ADDENDUM NO. 4:

Date: February 13, 2026
 Project: Verbena HS Gym
 DCM# 2025629
 WSM# 25-032

Owner: Chilton County Board of Education
 Architect: Ward Scott Morris Architecture, Inc.

PROJECT: Verbena HS Gym	ENG #2559 ARCH #25-032 DCM #2025629	DATE: February 13, 2026
-----------------------------------	---	-----------------------------------

E201

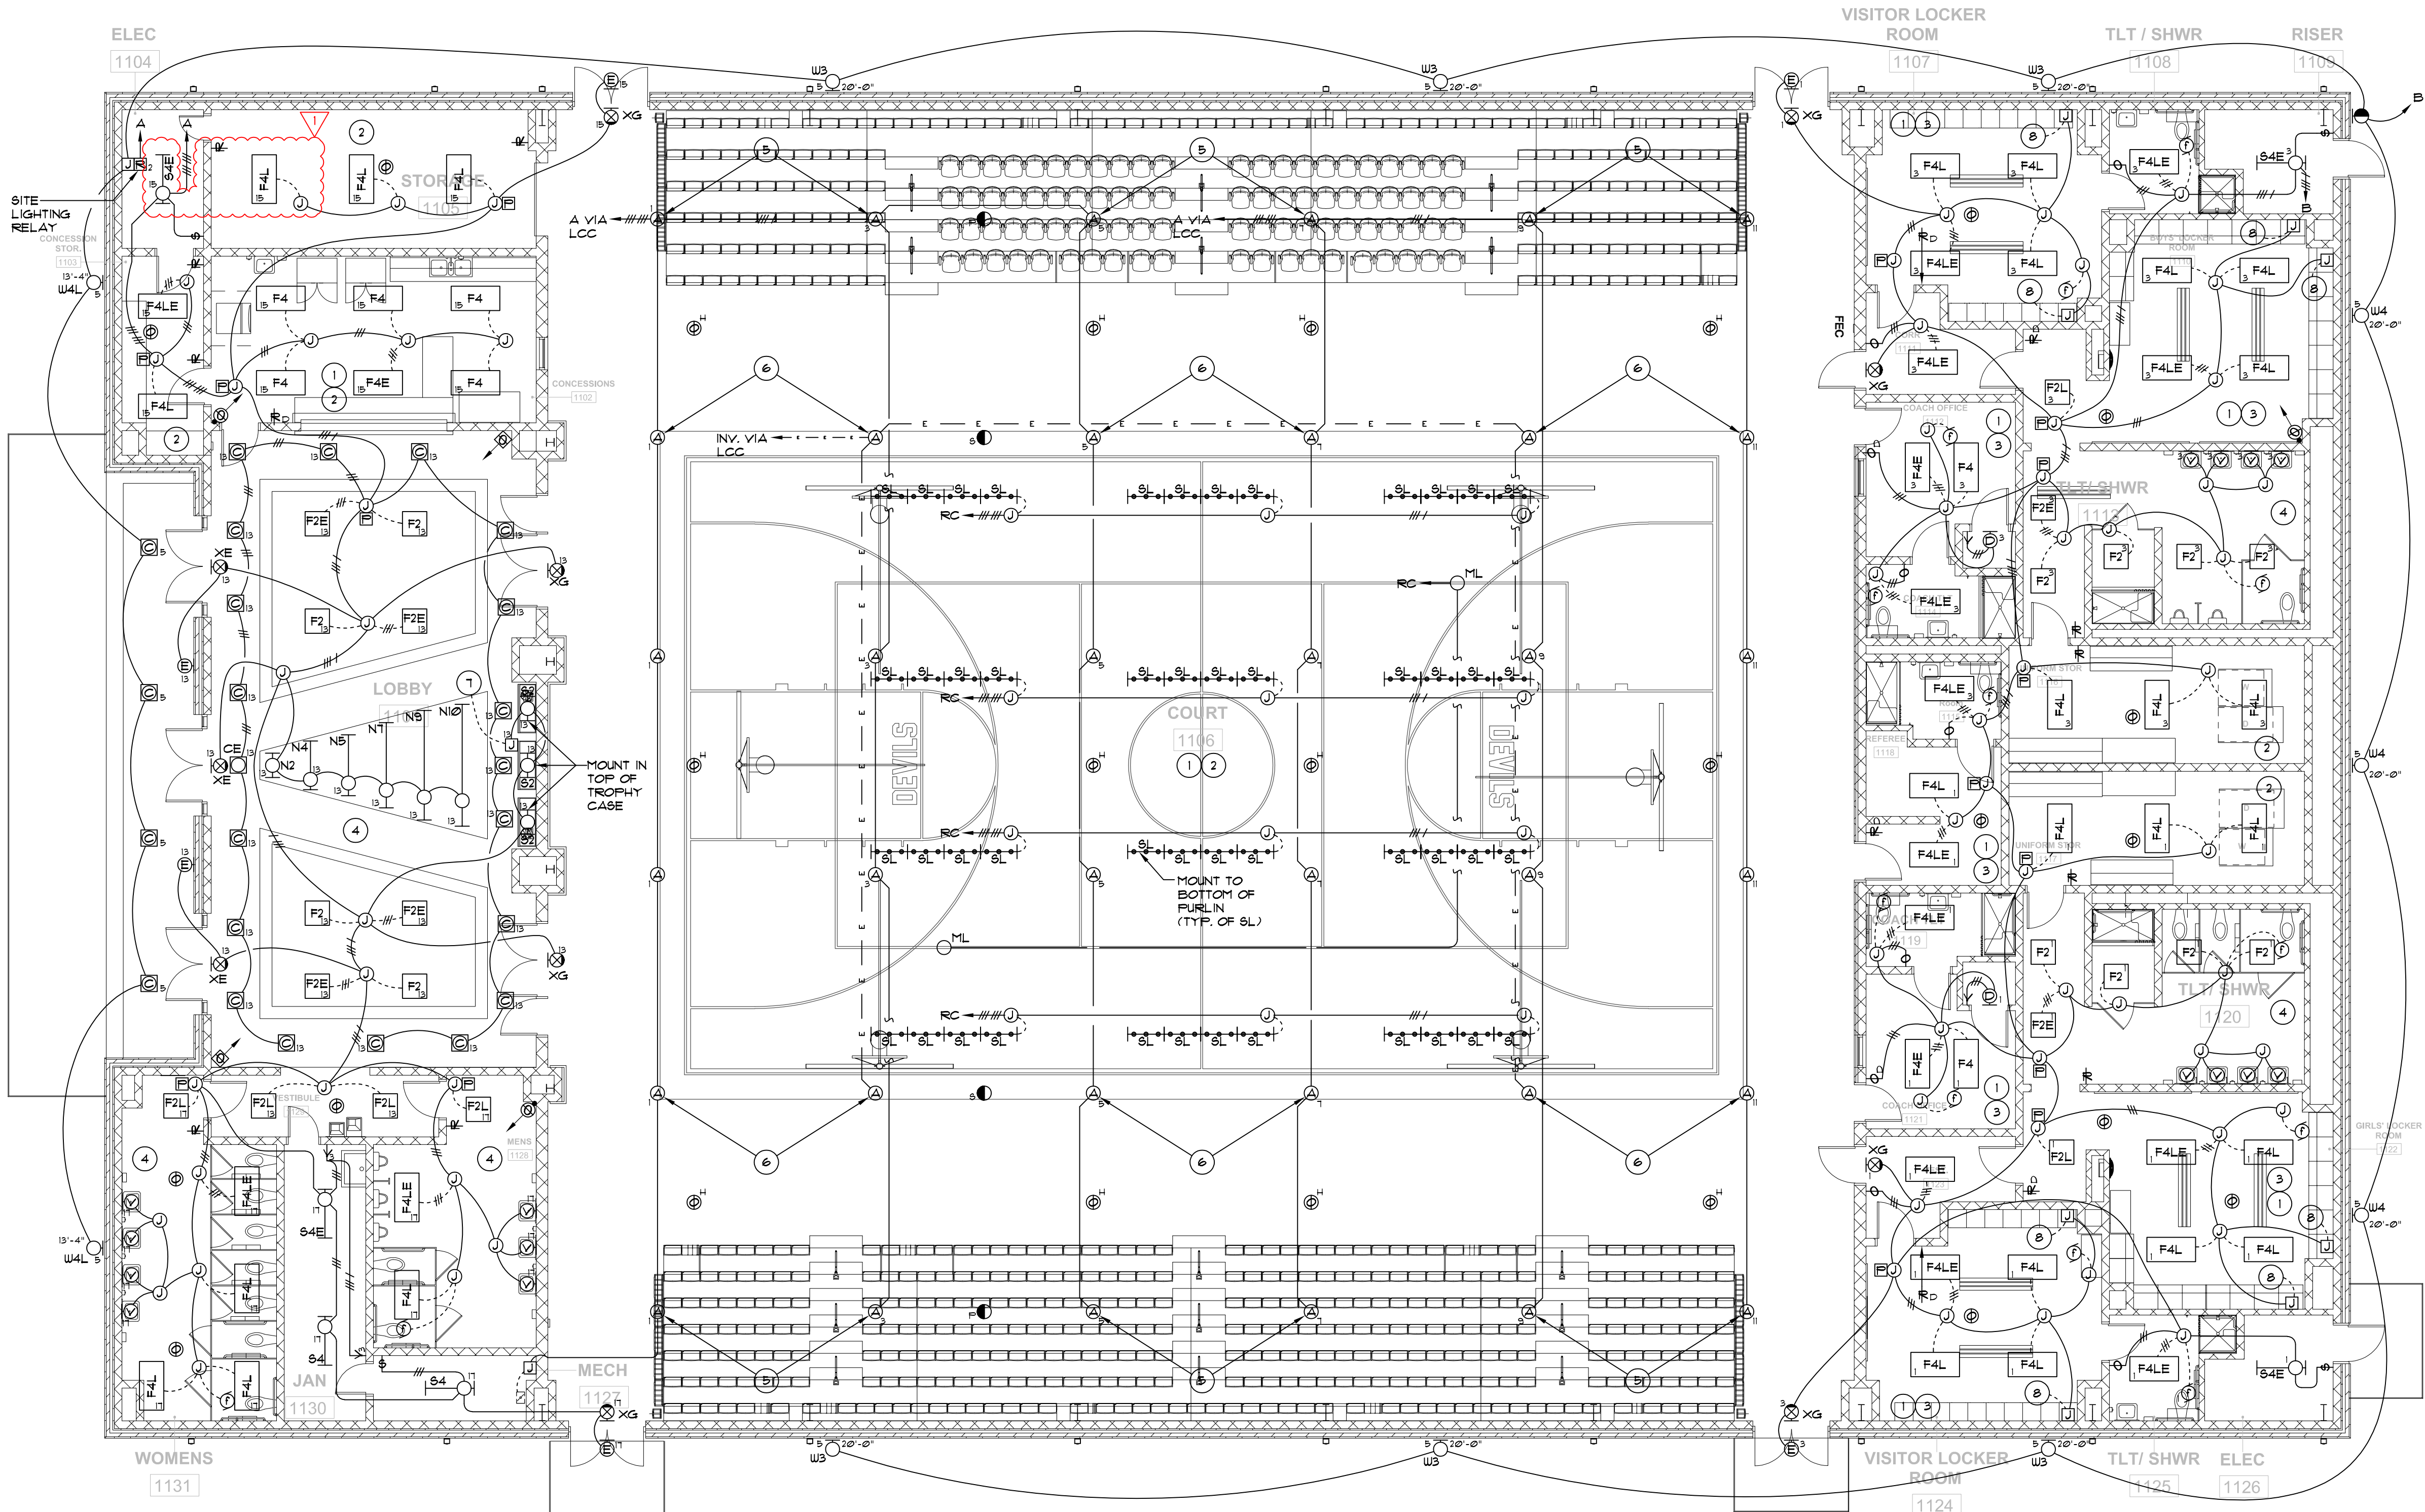
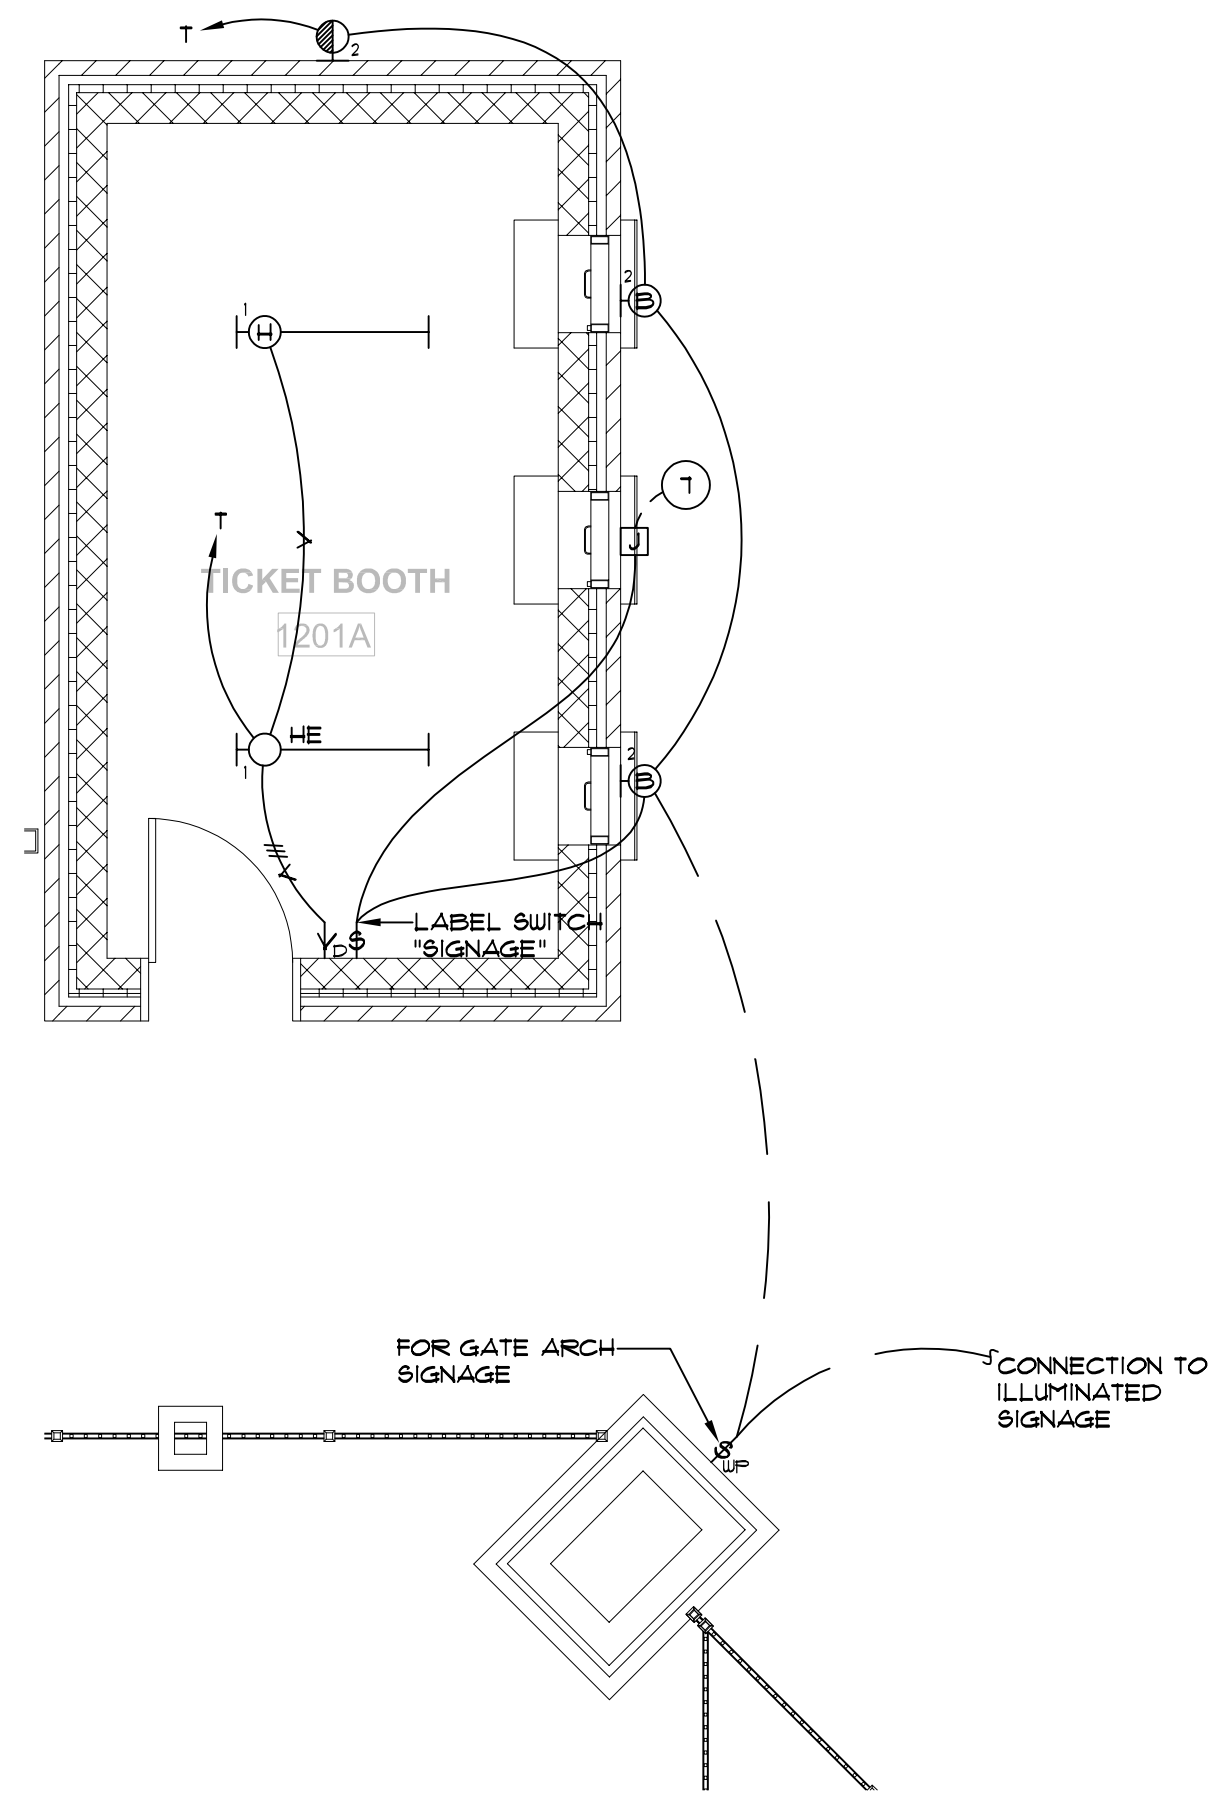
- e. Restroom Building – Power Wiring Plan, Jan 1303: Connection to circulator pump removed
4. Sheet E201, Gymnasium – Lighting Plan:
 - a. Elec 1104: 'S4' luminaire removed

- b. Storage 1105: 'F4L' luminaire and additional wall switch added
